ROCHESTER GAS AND HEATING CORPORATION • 19 EAST AVENUE, ROCHESTER, N.Y. 14610

February 1, 1982

Subject: SEP Topics VI-2.D and VI-3  
R. E. Ginna Nuclear Power Plant  
Docket No. 50-244

### COMMENTS ON NRC SAFETY EVALUATION

FIGURE 1  
CONTAINMENT TEMPERATURE  
STEAM BREAK HZP  
1/2 SPRAY SYSTEM

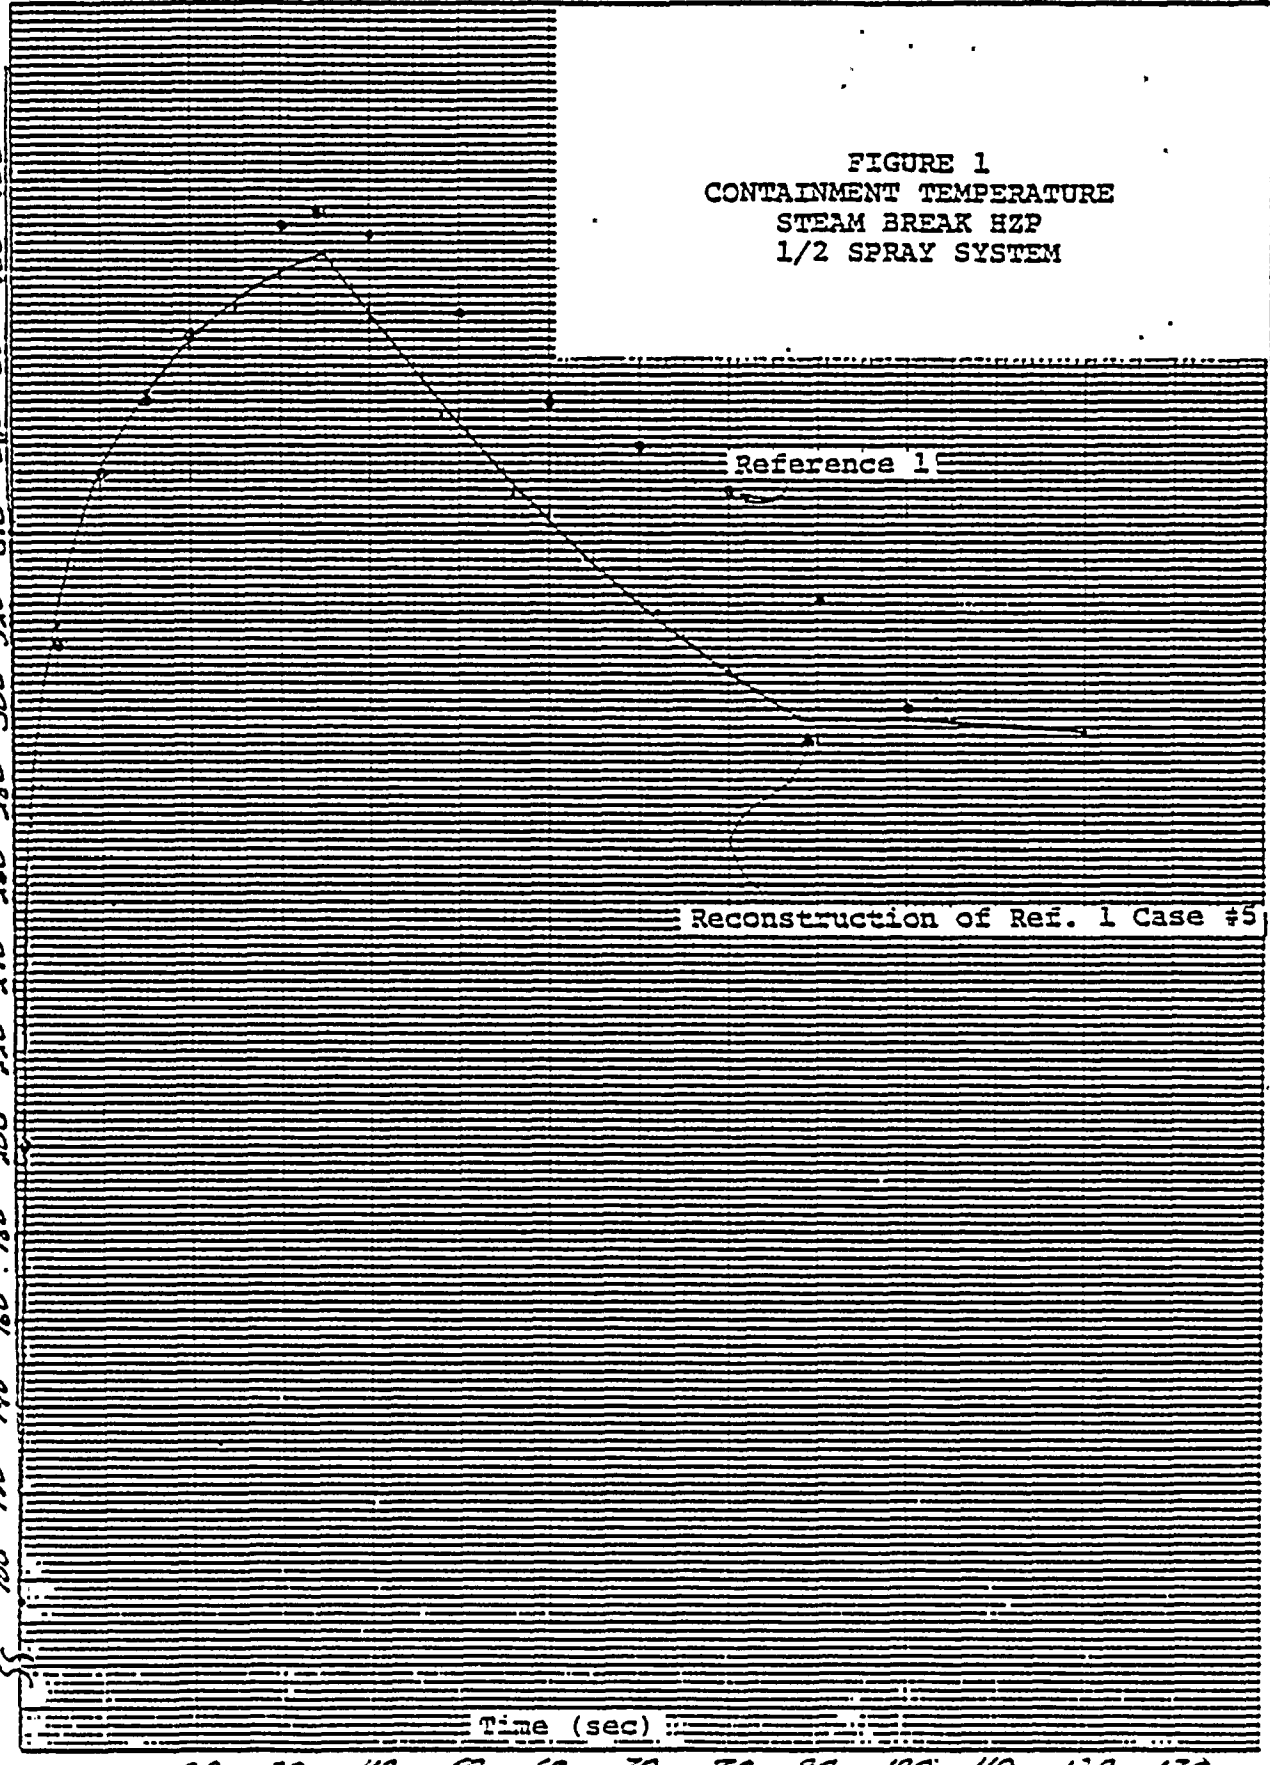
The highest containment pressure was calculated in Reference 1 to occur for a large steam line break at HZP with failure of one spray train. The input for this case was run using CONTEMPT-EI/28B. Figure 1 and 2 illustrates the results of this run and points taken from Reference 1. The following peak temperature and pressure was obtained:

FIGURE 4  
CONTAINMENT TEMPERATURE  
STEAM BREAK HZP  
1/2 SPRAY SYSTEM

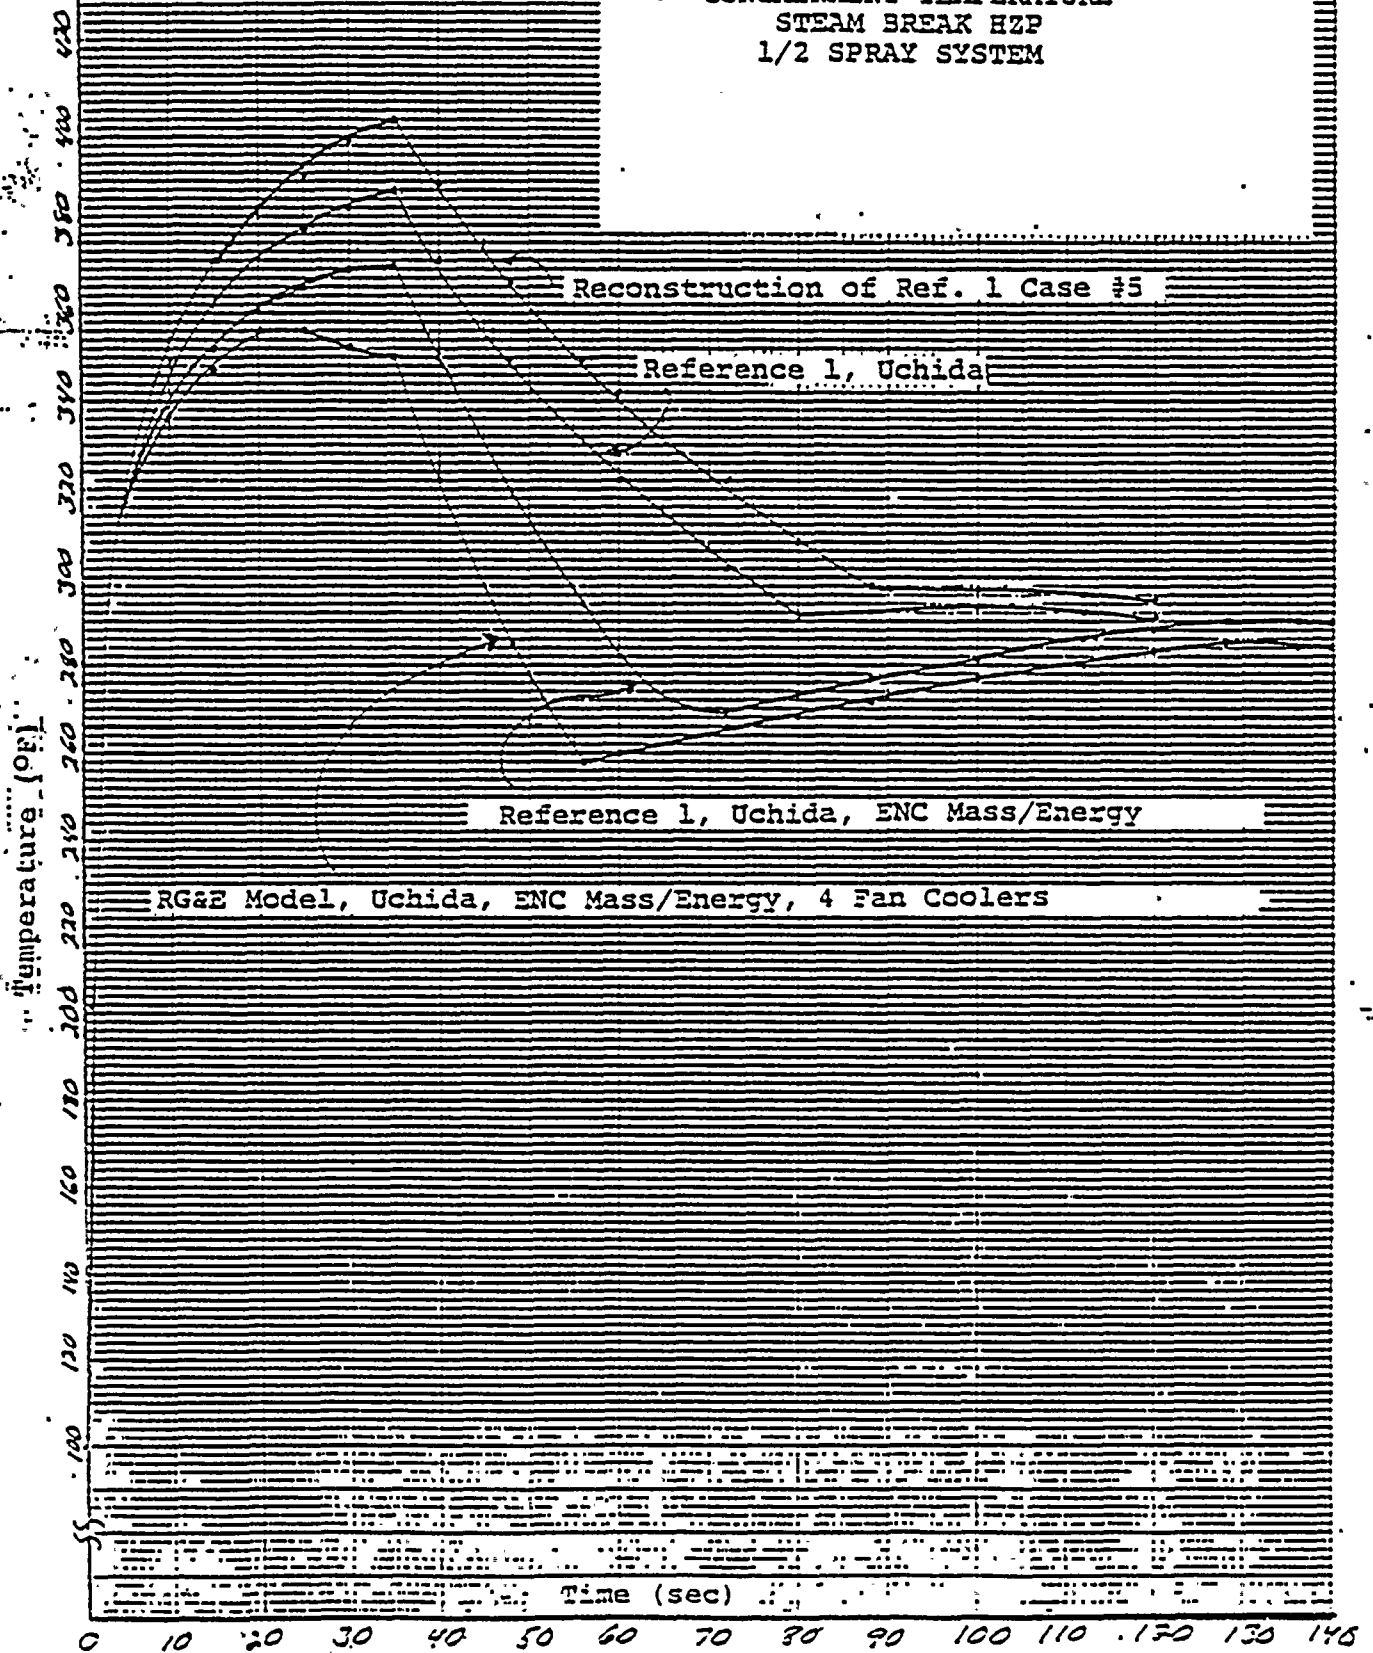
Figures 4 and 5 illustrate the effect of Uchida, ENC mass and energy, and the RG&E containment heat sink model on the worst case containment response presented in Reference 1 (#1, #4, #5, and #11 of Table 1).

FIGURE 1  
CONTAINMENT TEMPERATURE  
STEAM BREAK H2P  
1/2 SPRAY SYSTEM

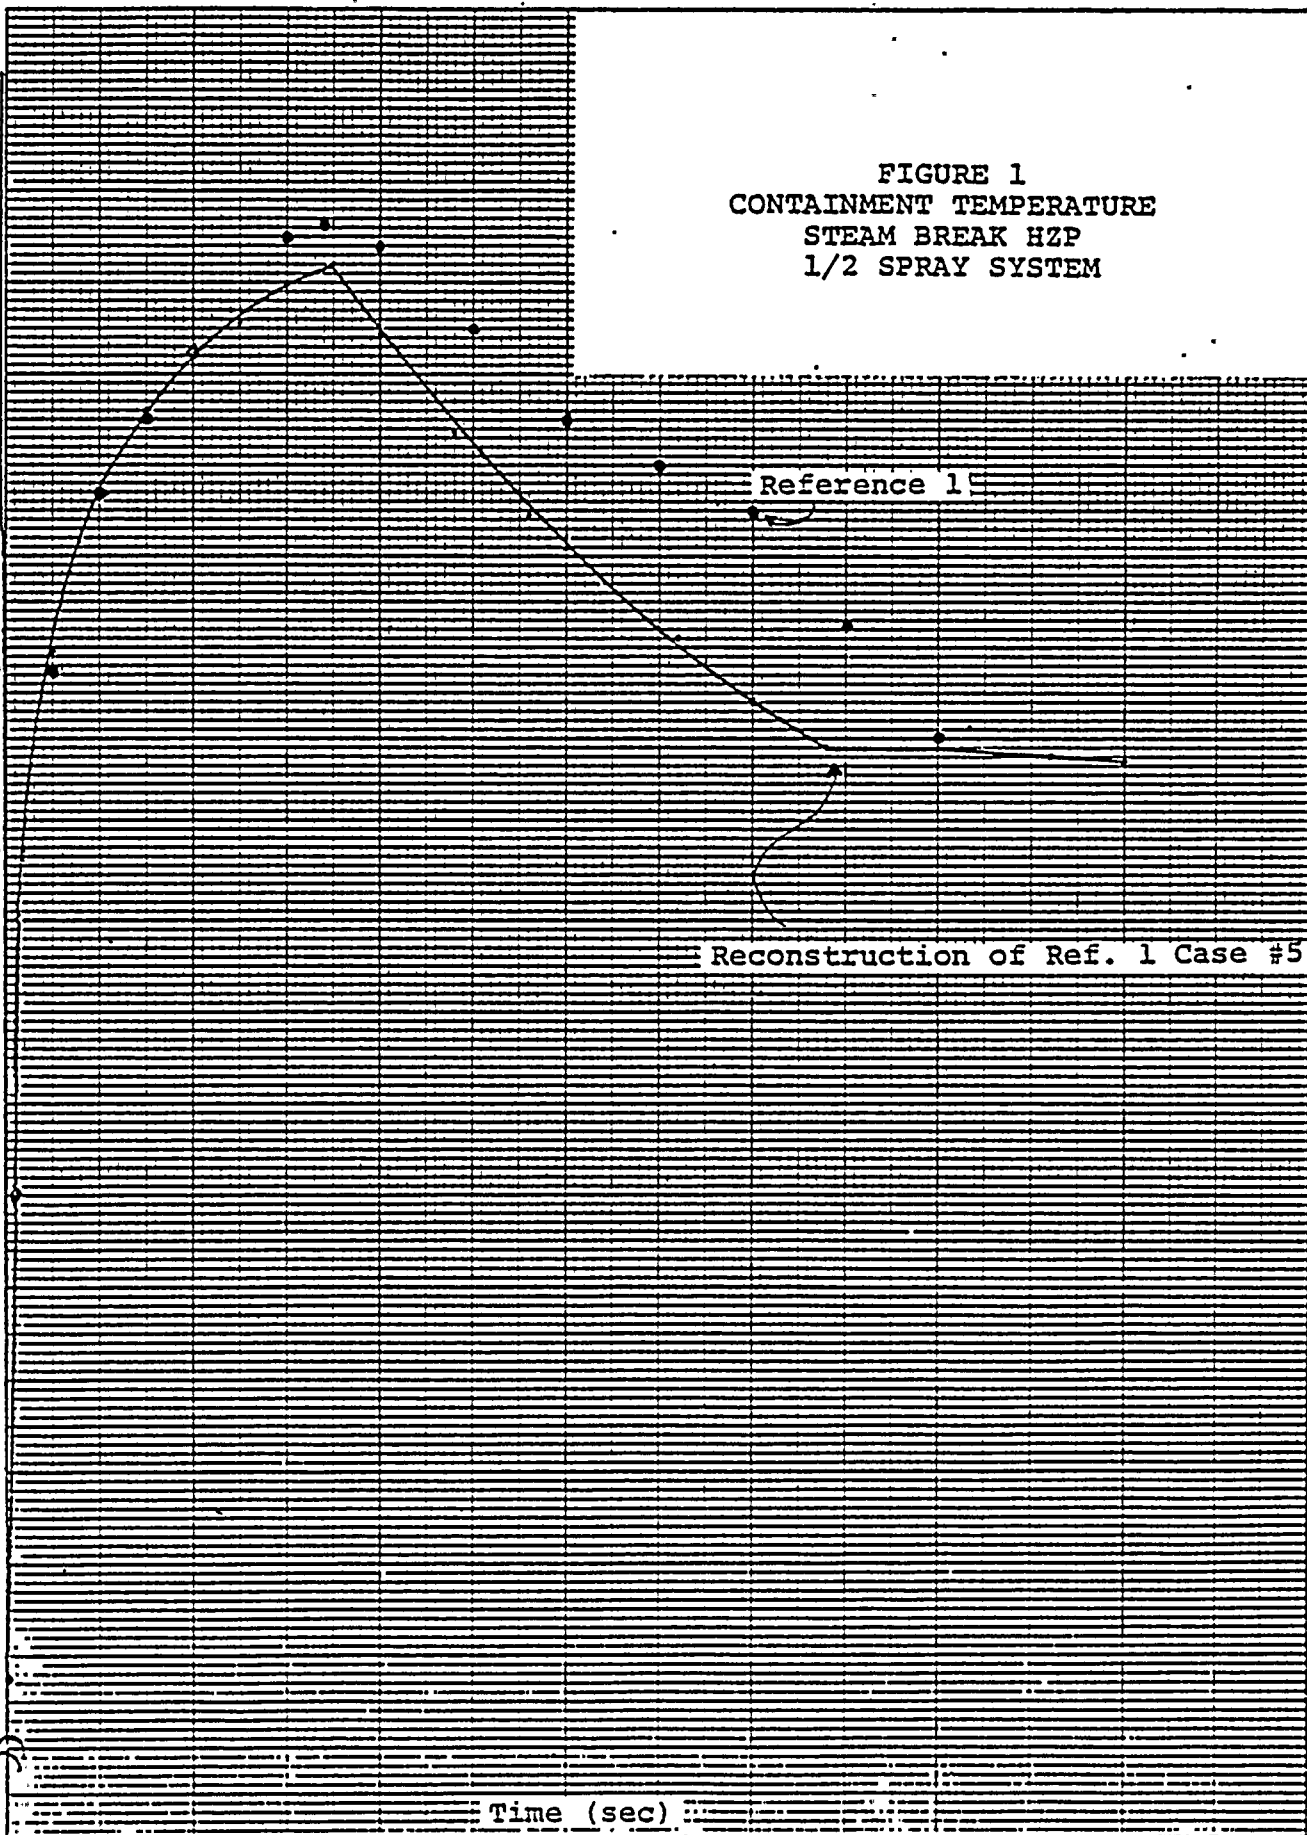
The highest containment pressure was calculated in Reference 1 to occur for a large steam line break at HZP with failure of one spray train. The input for this case was run using CONTEMPT-EI/28B. Figure 1 and 2 illustrates the results of this run and points taken from Reference 1. The following peak temperature and pressure was obtained:

FIGURE 4  
CONTAINMENT TEMPERATURE  
STEAM BREAK H2P  
1/2 SPRAY SYSTEM

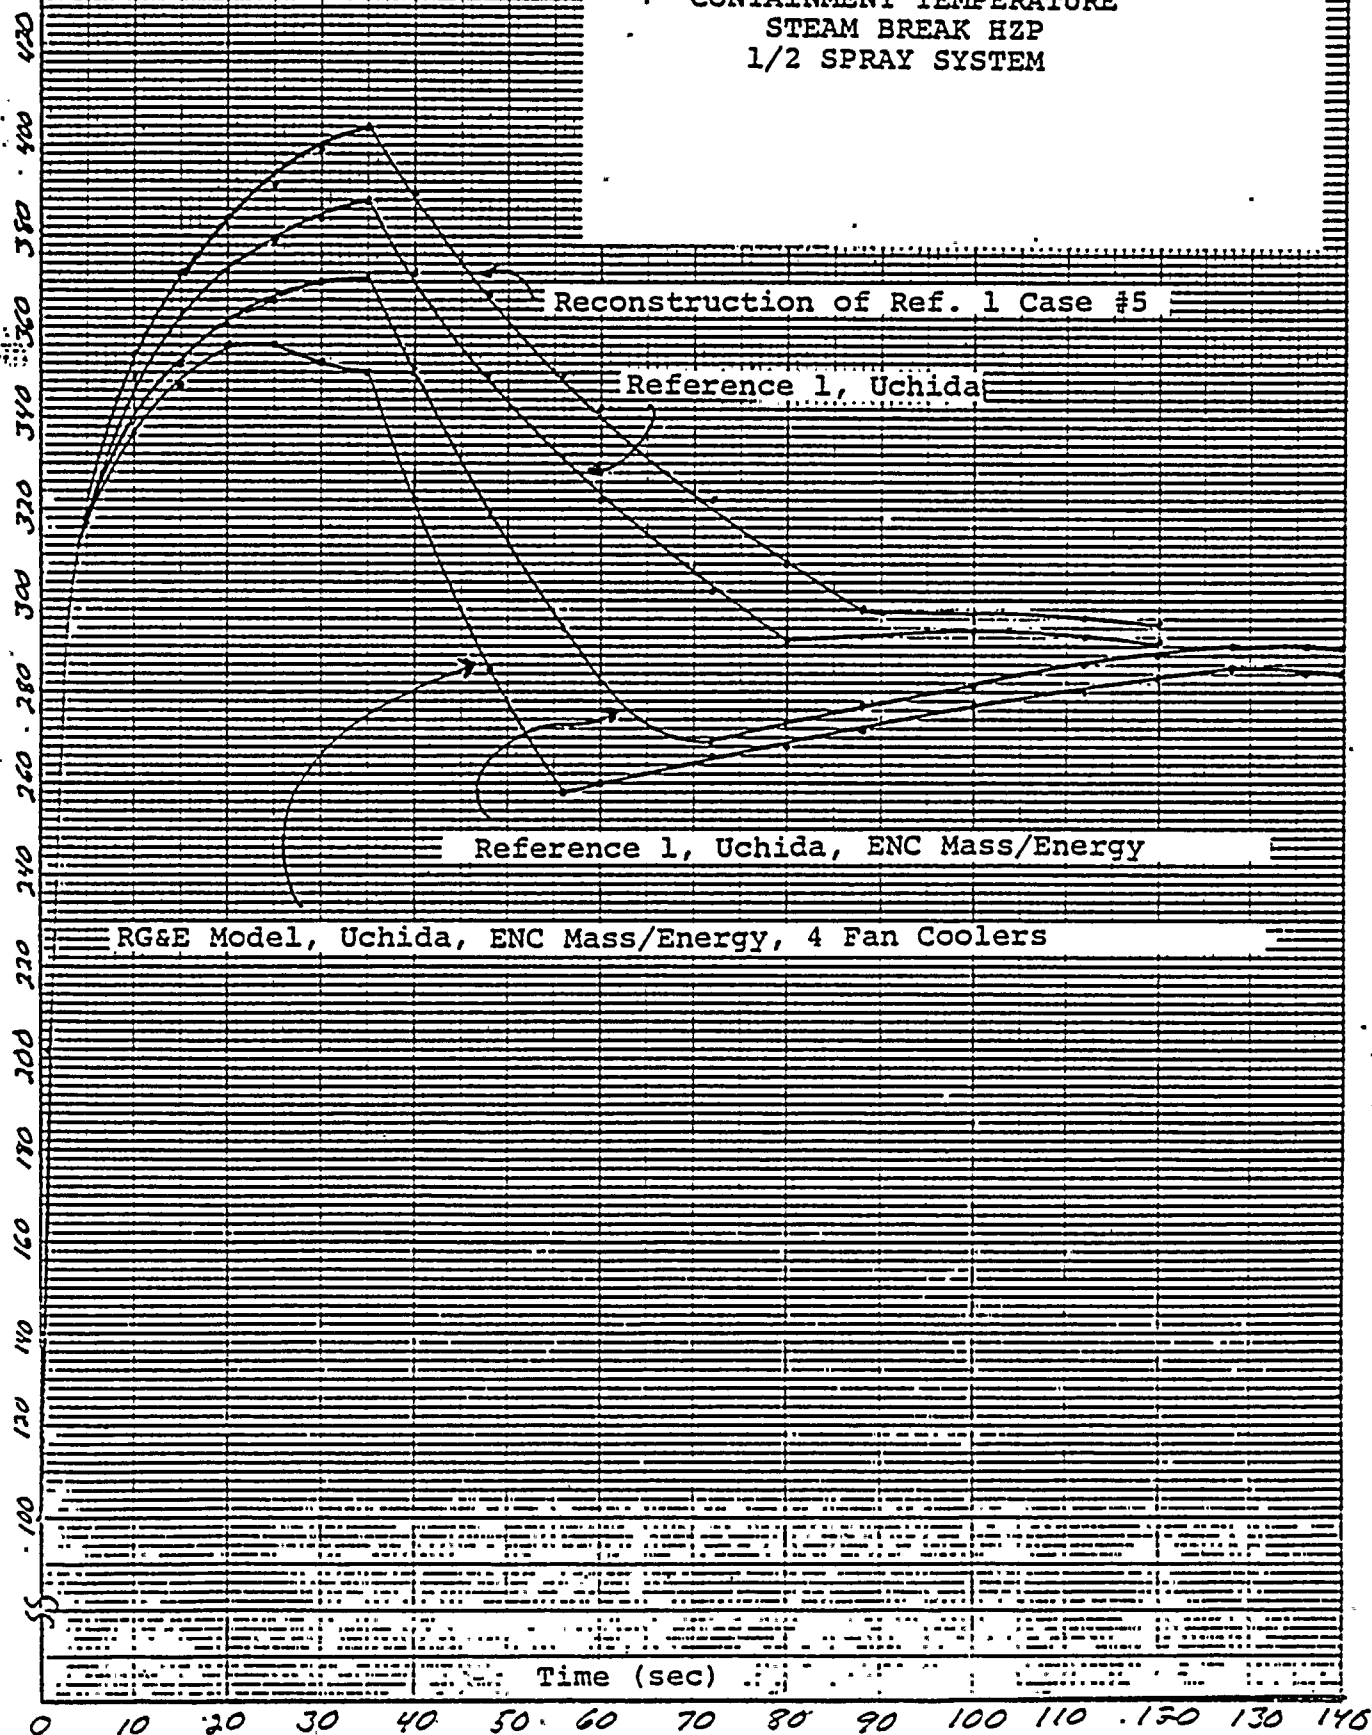
Figures 4 and 5 illustrate the effect of Uchida, ENC mass and energy, and the RG&E containment heat sink model on the worst case containment response presented in Reference 1 (#1, #4, #5, and #11 of Table 1).
